San Elijo Student Center Addition and Remodel

MIRACOSTA COLLEGE

RECORD DRAWINGS

Construction Documents
September 19, 2006

ADDENDUM NO. -5
DATE: 11/15/06
DSA NO:4-107874
THIS REVISES IN PART
SHEET AS-0 & AS-1
SHEET: AR-1

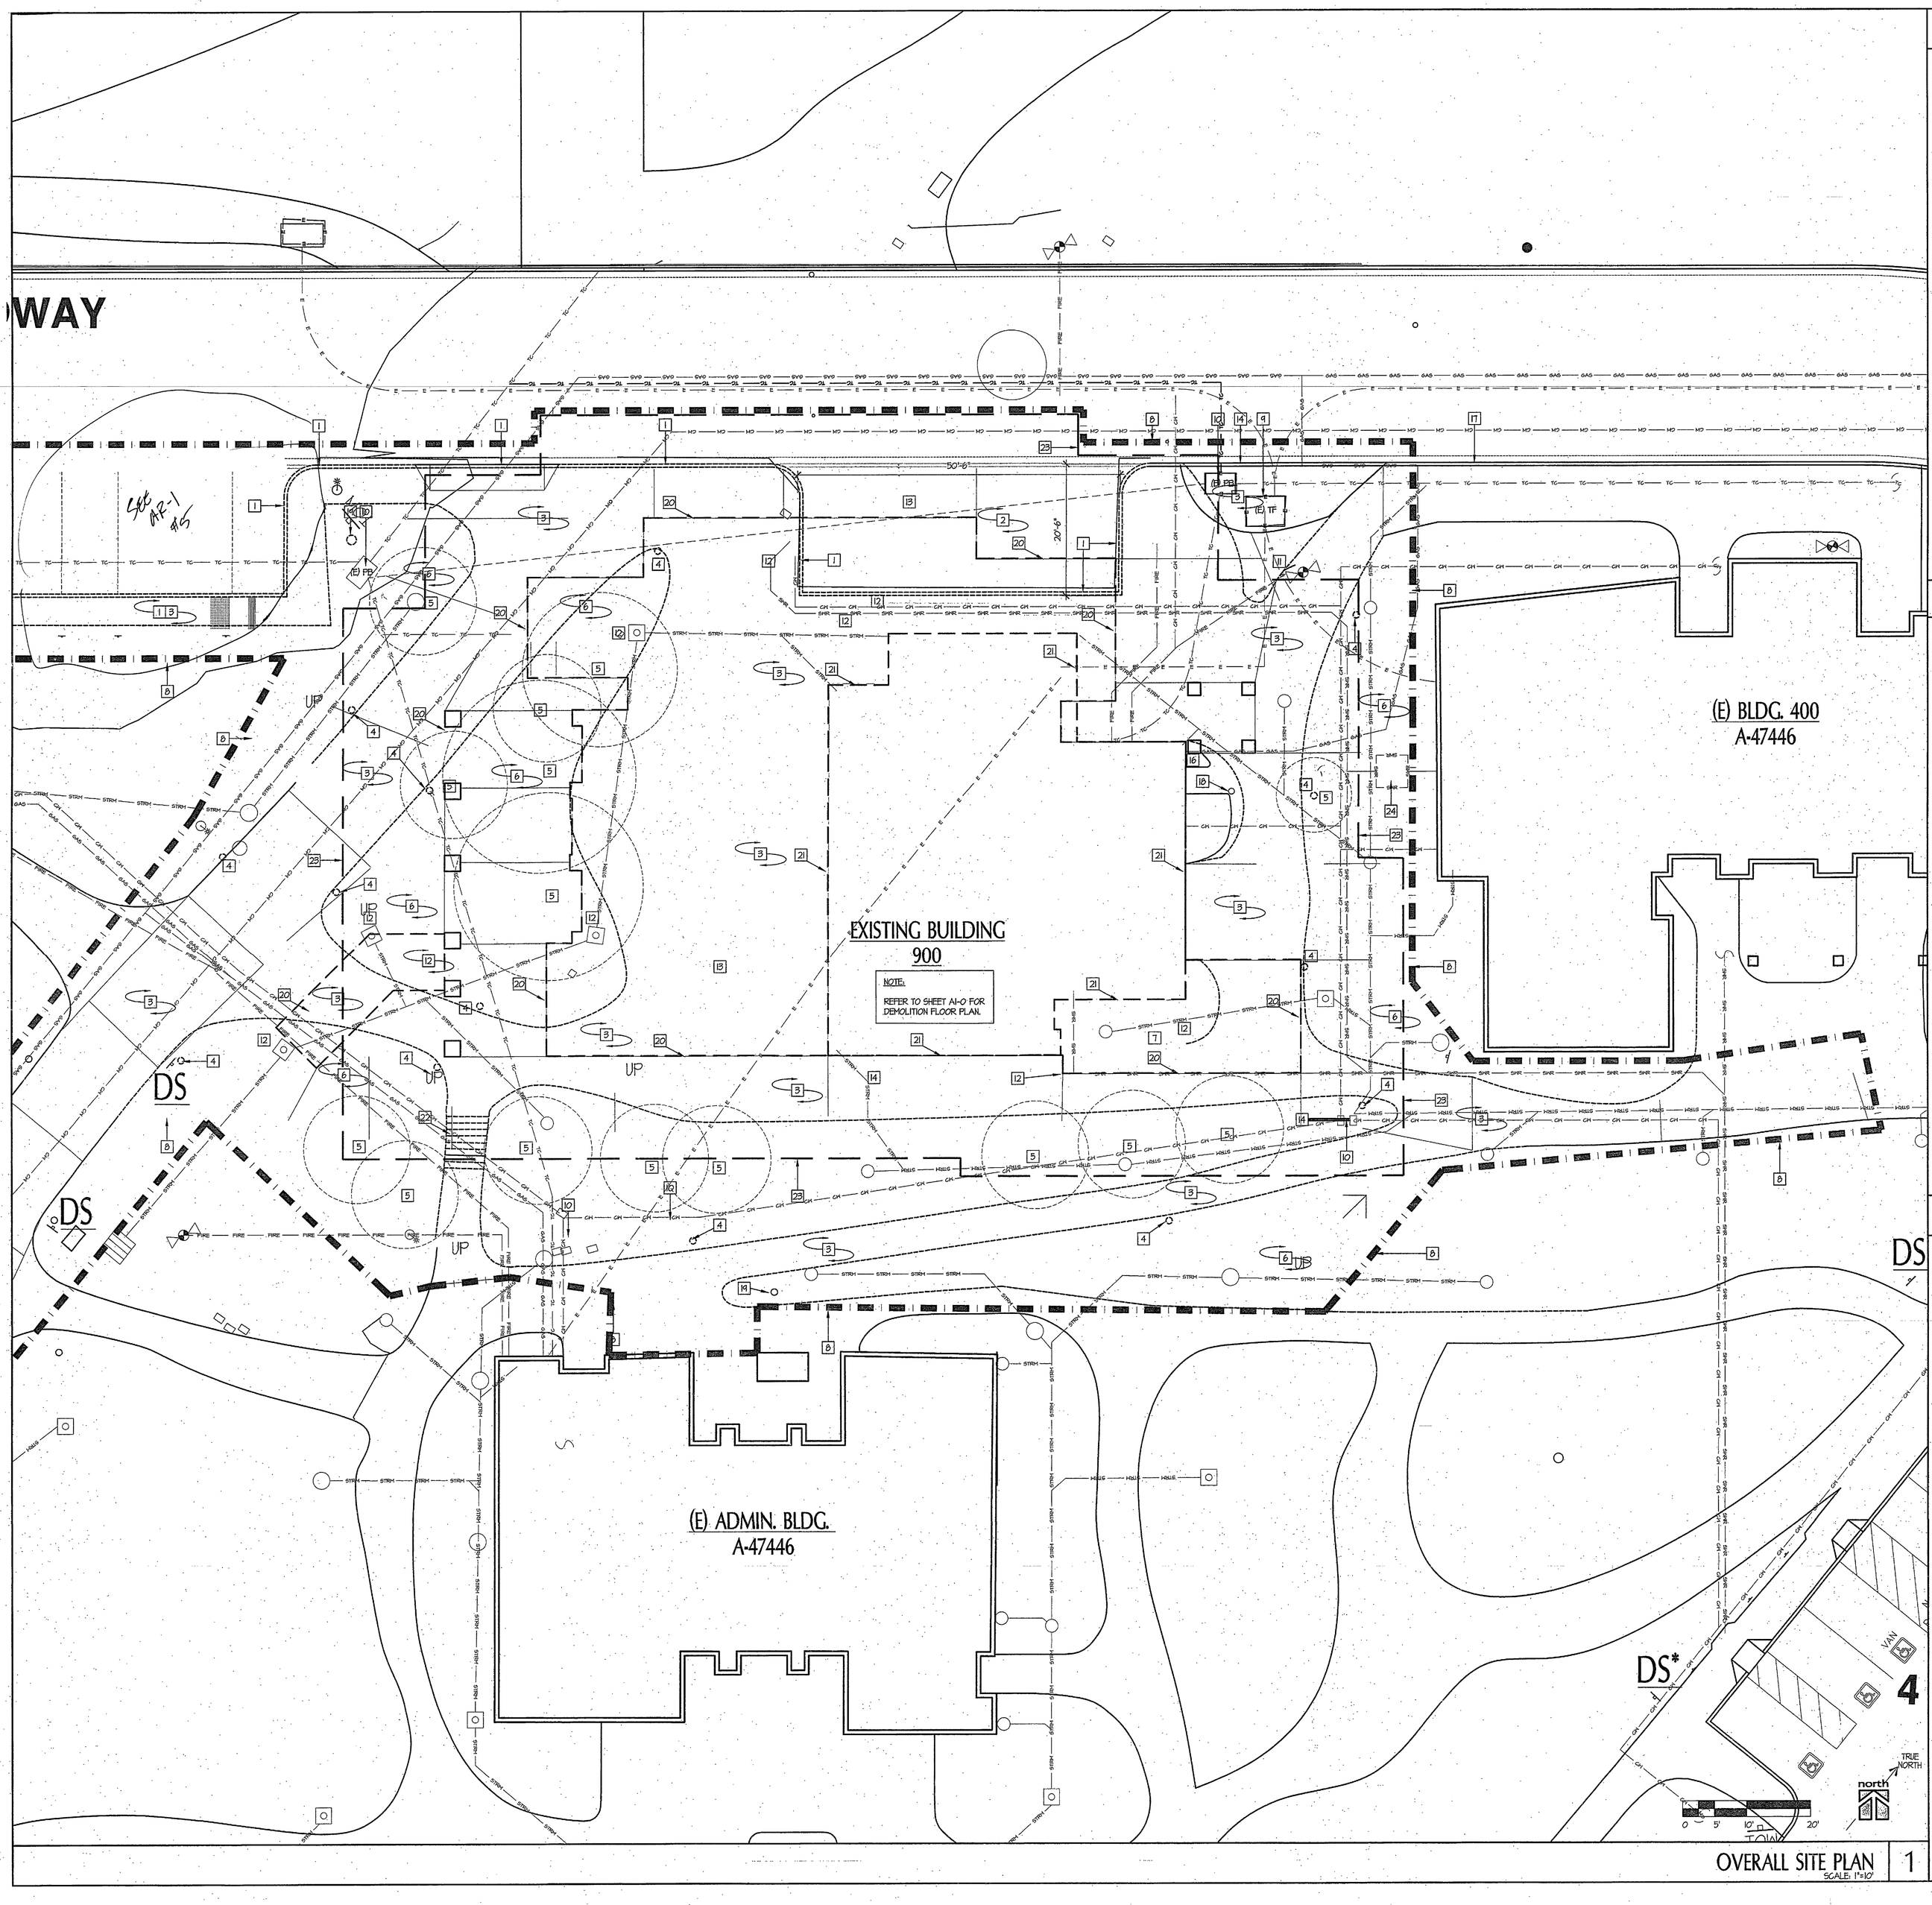
b. Area of work boundary has been adjusted. See Drawing AR-1 issued with this addendum.

c. Site elevations and layout have been revised at southeast side of building as shown on Drawing AR-2 issued with this addendum.

SHEET A2-1

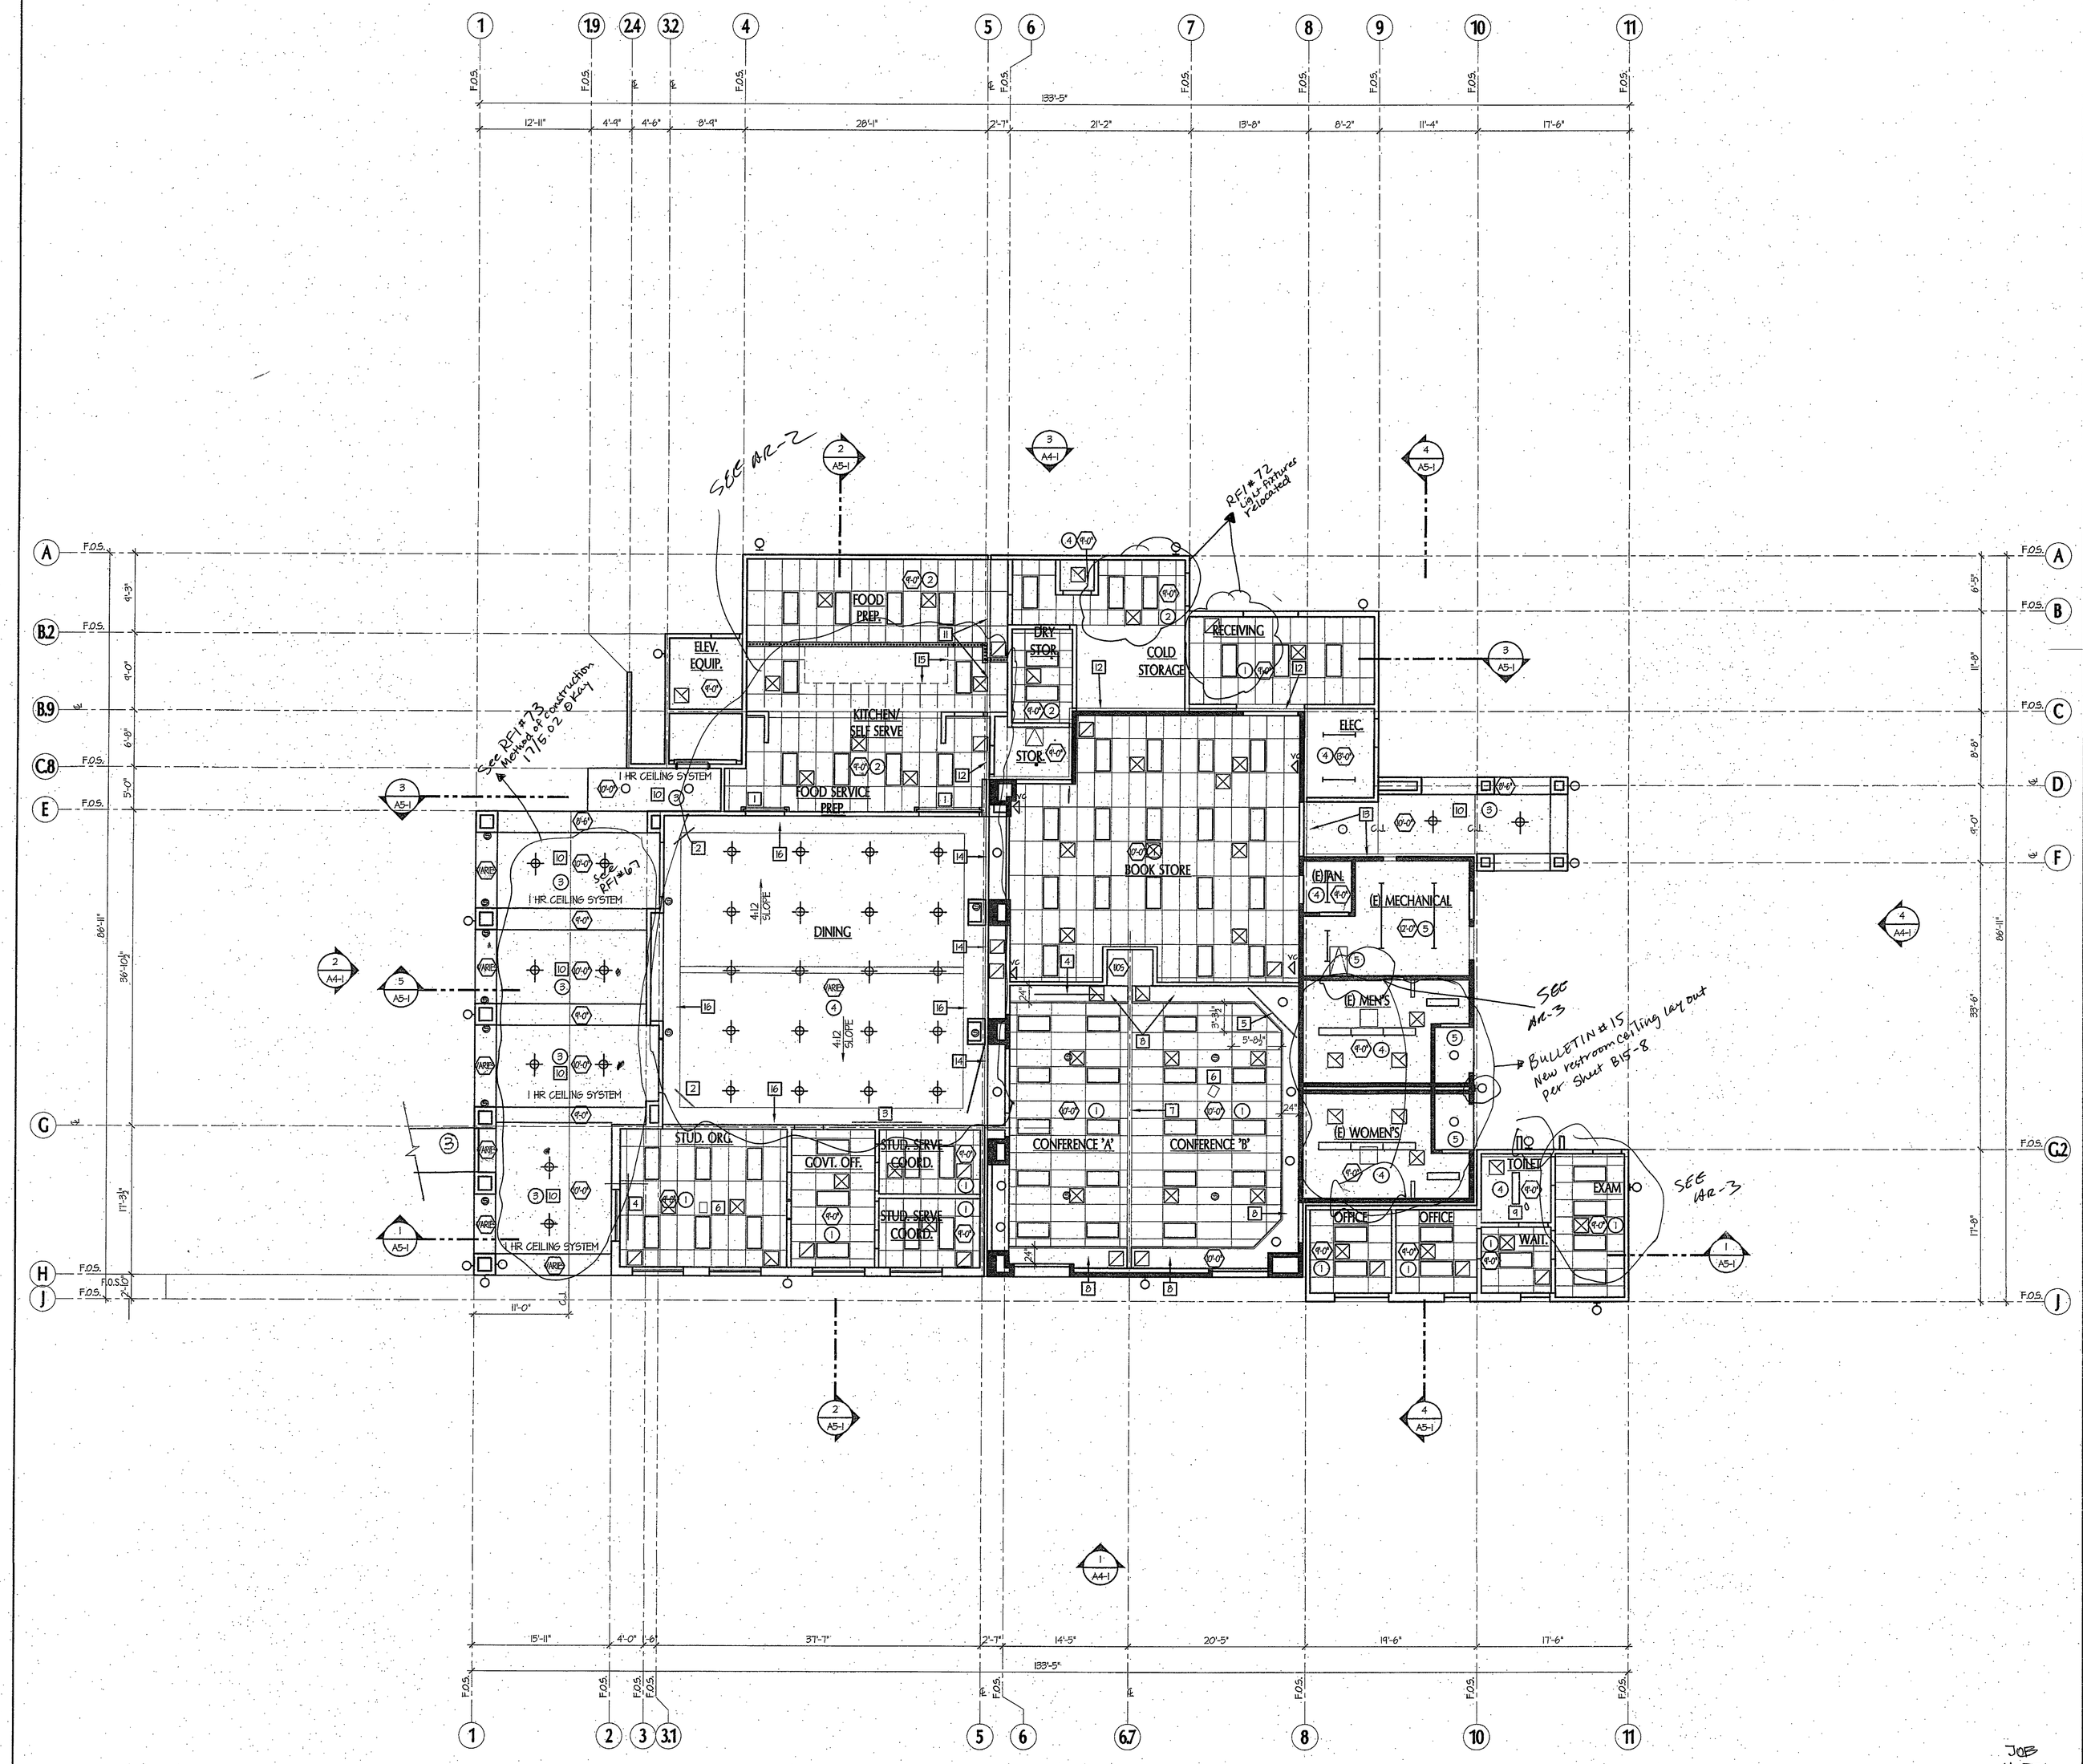
a. 1 hr ceiling system: See Section 1 and 5 on Sheet A5-1 for reference to assembly UL 519.

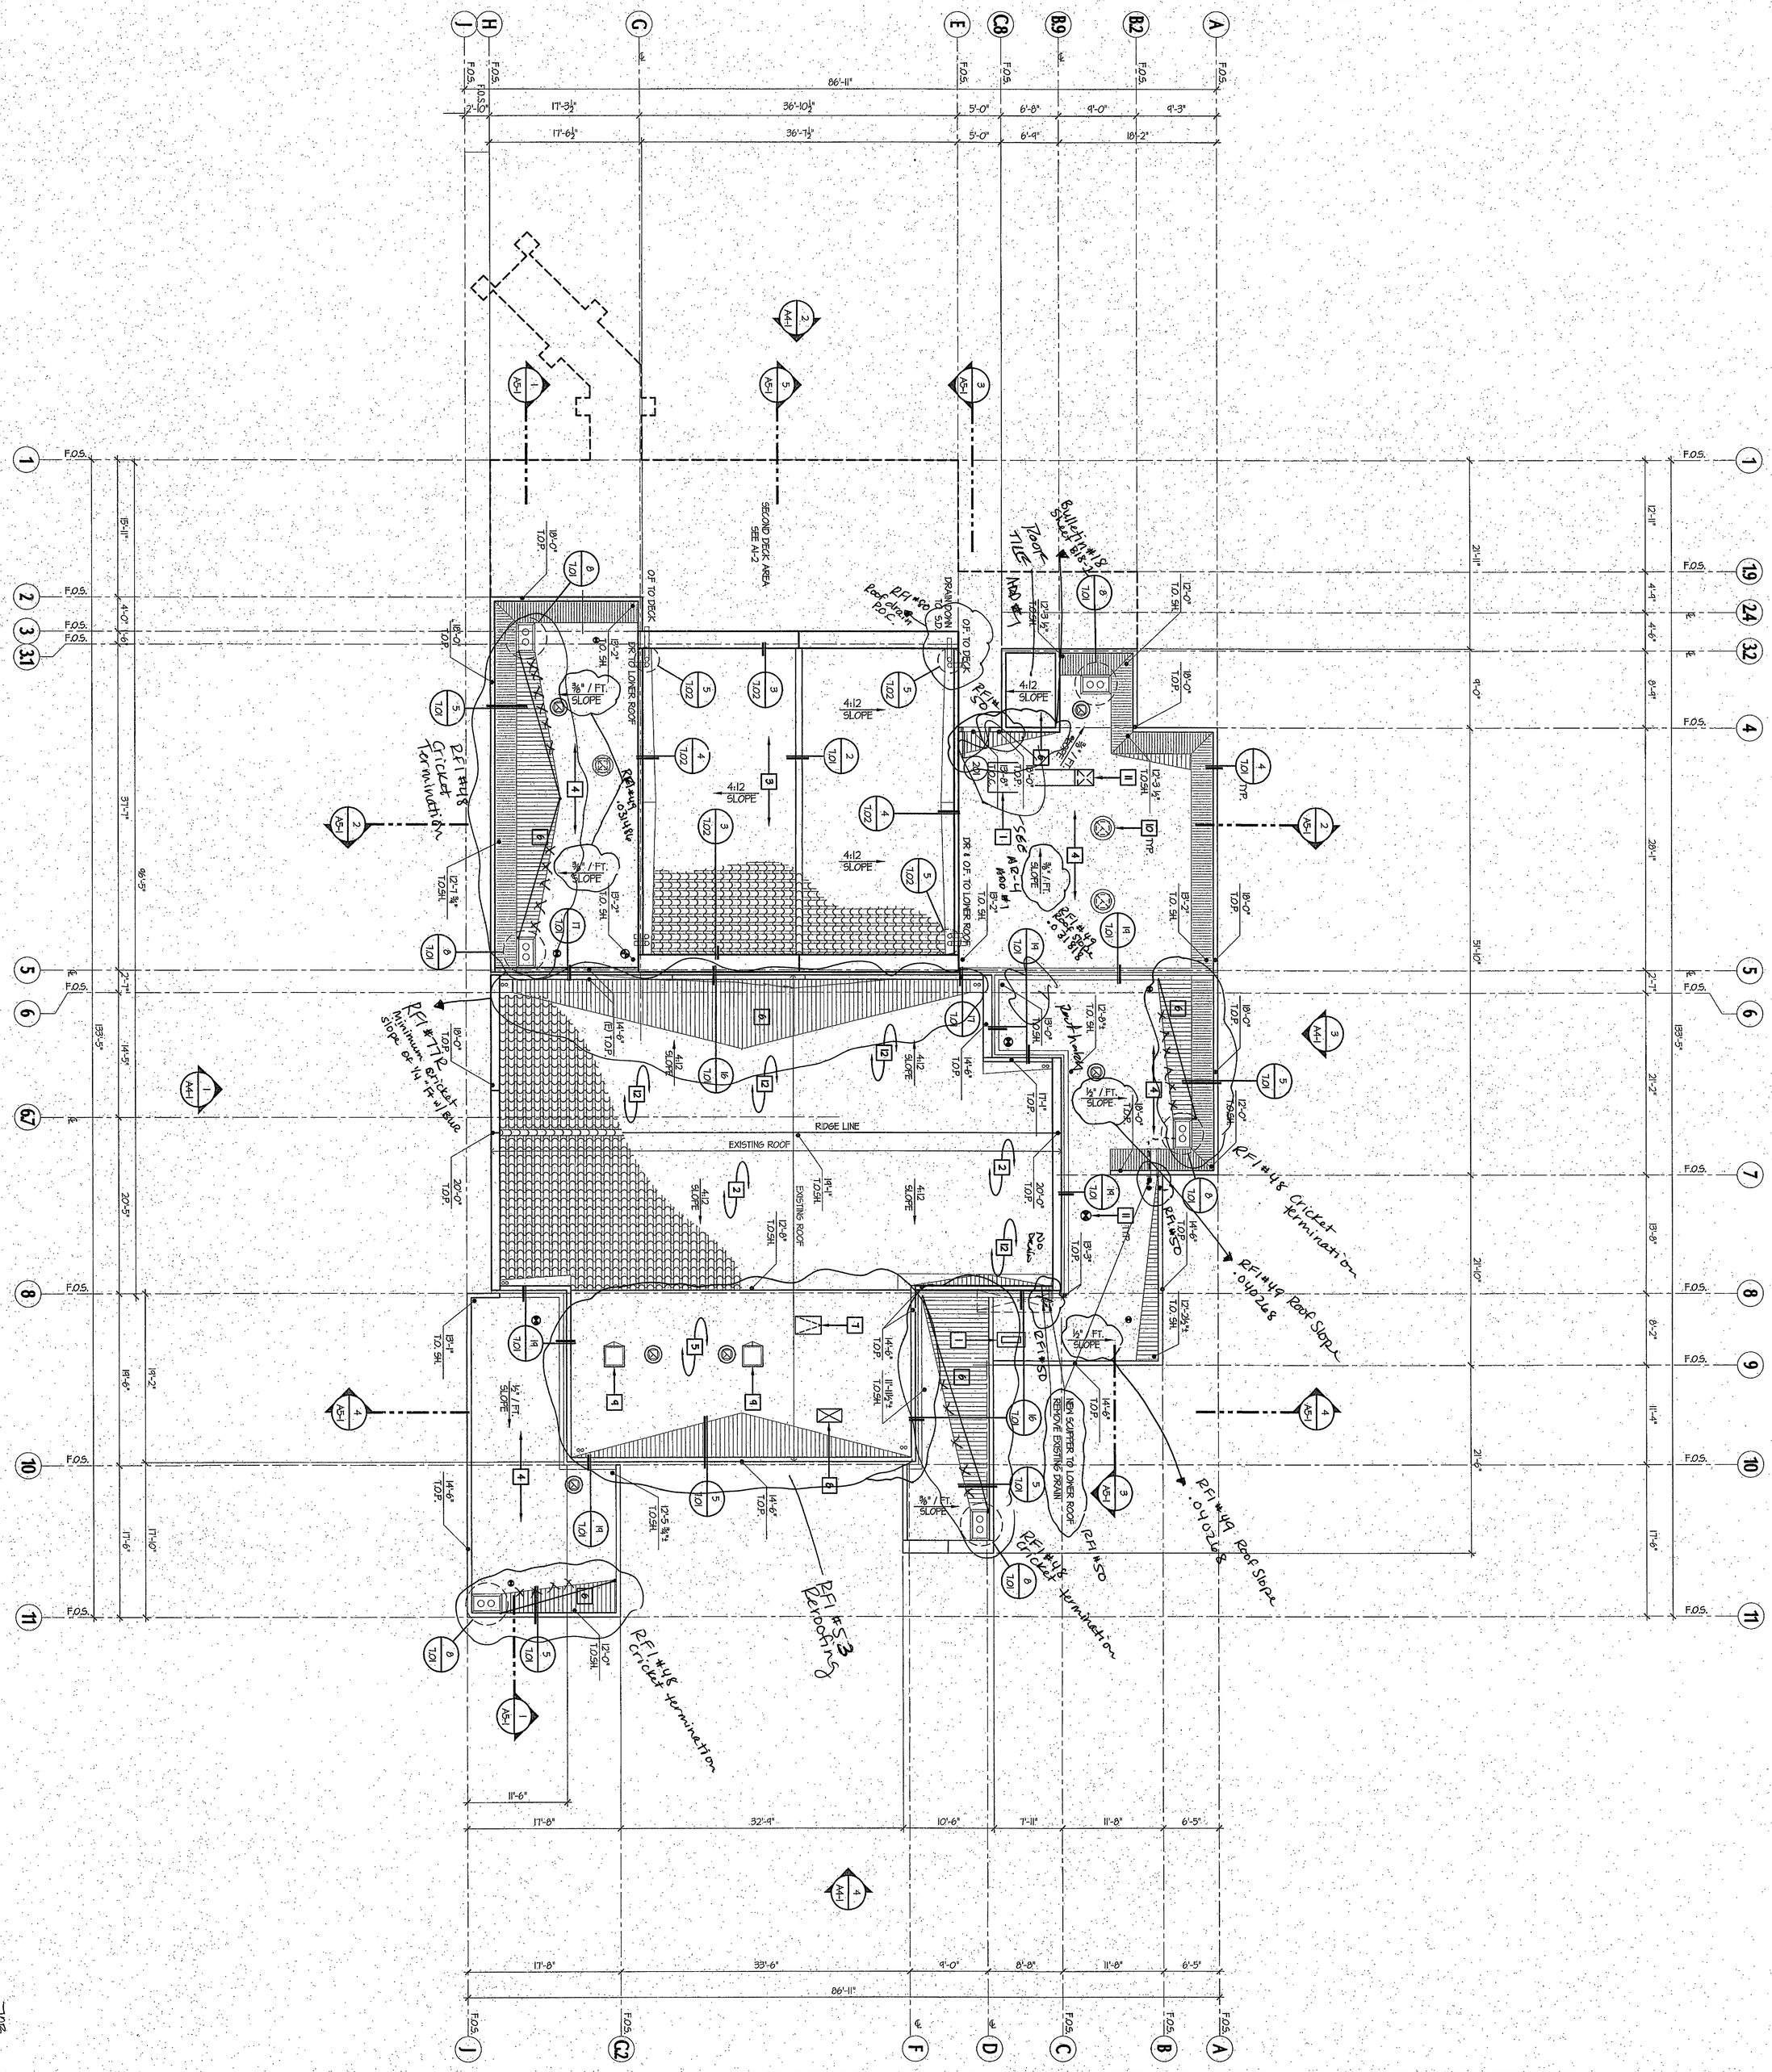
1. MECHANICAL UNIT PLATFORM, SEE DETAIL 2/7.01
2. EXISTING CLAY TILE ROOF TO REMAIN - (U) NEW: Repair existing Roof where required for construction, clay tile to match existing
3. CLAY TILE ROOF OVER ADDITION, SEE DETAIL 9/7.01
4. BUILT UP ROOF SYSTEM OVER ADDITION
5. EXISTING BUILT UP ROOFING TO REMAIN
6. NEW CRICKET SLOPE 3:12
7. EXISTING ROOF HATCH
8. EXISTING MECHANICAL DUCT NEW mech. Unit See Sht. M2-1
9. EXISTING SKYLIGHT
10. EXHAUST FAN, SEE DETAIL 7/7.01
11. DUCT PENETRATION, SEE DETAIL 10/7.01
12. REPLACE ALL EXISTING DAMAGED ROOF TILE IN THIS AREA BY NEW TILE.
13. RFI #77 - Roof Hatch – See A2-4 for location
    RFI #87 - Substitute galvanized twisted wire for brass twisted wire.
